Subject: Product workmanship improvement

PCN-01329

PCN Number: PCN-01329		PCN Date: Mar 30th, 2020
Title: Product workmanship improvement. The change is to use wire solder dipping instead of wire welding technique to improve the process.		
Proposed 1st Ship Date: As soon as customer approved.		Estimated Sample Availability: 50 Samples available immediately if required.
Change Type:		
Assembly Site	Design	Electrical Specification
Test Site	Assembly Process X	Mechanical Specification
Test Process	Assembly Material	Packing/Shipping/Labeling
PCN Details		
Description of Change:		
Using wire solder dipping to replace the wire welding. This technique change will reduce the assembly complexity and then improve the quality and stability. Macom test data shows that there is no significant changes to the test data as seen in Appendix I.		
MABA-009572-CF18A0		
New Method		Existing

MABACT0069

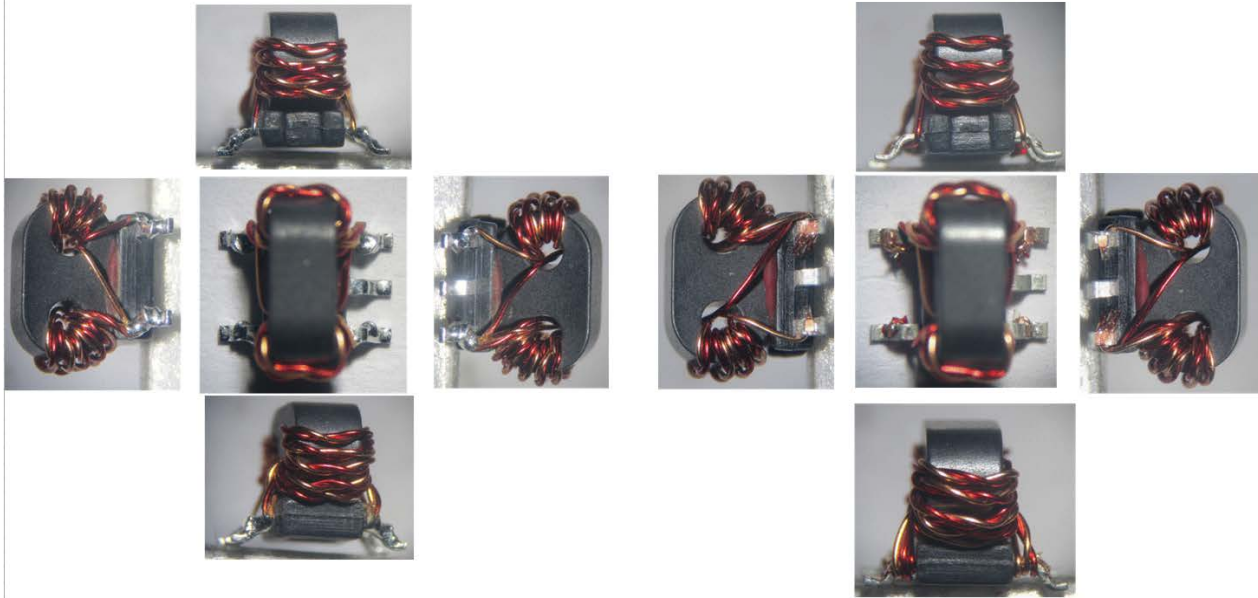
Reduce the assembly complexity to improve the quality and stability.
